Subject: RE: Highland Views Manufactured Housing Park & Mixed Use Development -

Subdivision & Site Plan Review

I have reviewed the following information submitted by Terradyn Consultants, LLC as part of the Subdivision & Site Plan applications for this project and offer the following comments:

TYPICAL M.H.P. STREET SECTION NOT TO SCALE

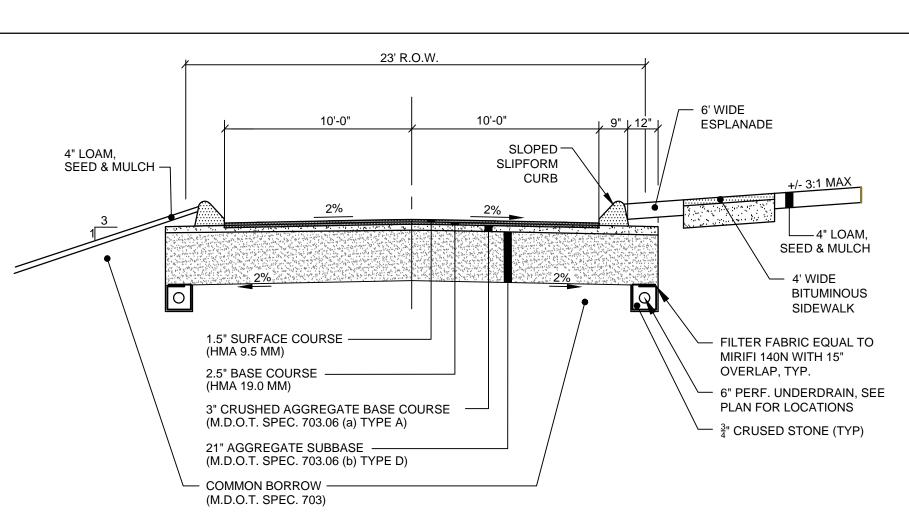
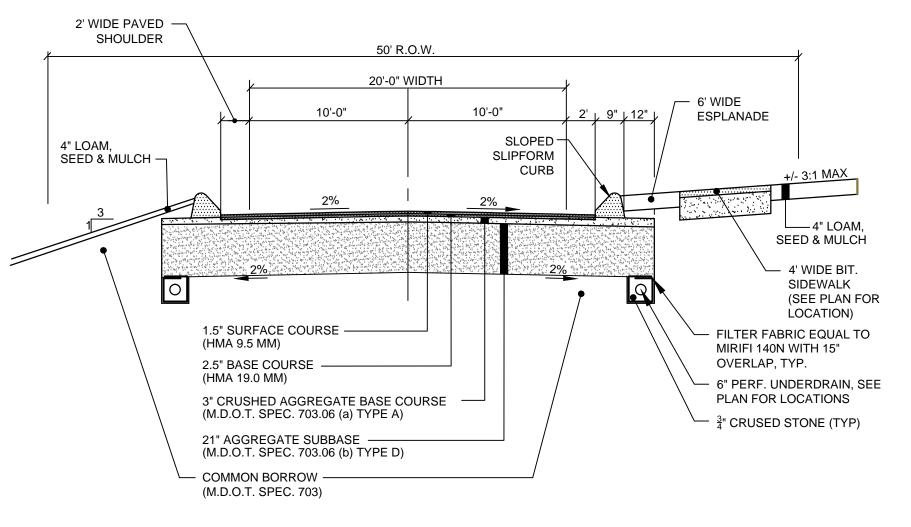
- Two road section details are provided on Sheet 7.2. I'm unclear as to which detail the interior road network is being built to. It's my understanding that the entire road network would need to be built to the major private road standard (with the 2' shoulders). The plan views seem to scale to a 20' wide pavement section curb to curb within the development. Please clarify. The manufactured housing overlay zone stipulates that the roads may be 20' wide. See 5.c.vii.a.2 of the attached overlay zone language.
